PLANNING BOARD DECISION

Application Type: **SITE PLAN REVIEW**

Project: **Temporary Mobile Substation**

Location: **0 – 14 Mill Street, Amesbury MA 01913**

PLANTING
PLAN

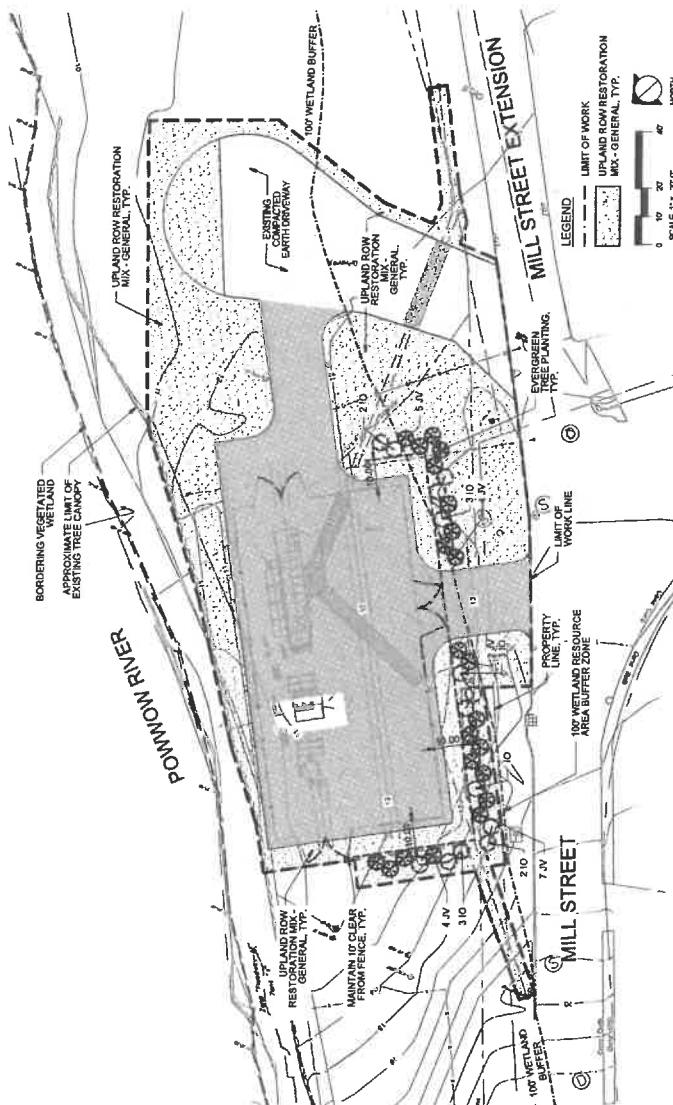
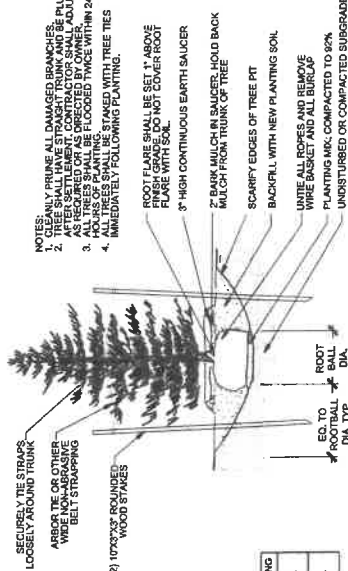
2. **Buffers and Screening:** The proposed activities and temporary substation shall be screened with landscaped screening as per Landscape Plan modified and approved by the Board per this Decision. At a minimum all vegetation installed as per approved landscape plan shall be 8-12 feet in height at the time of installation.

6. **Landscape Maintenance:** The landscape buffers shall be maintained at a minimum for the duration of the operation of the temporary substation and any damaged or dead plants shall be replaced immediately as per specifications outlined in the landscape plan.
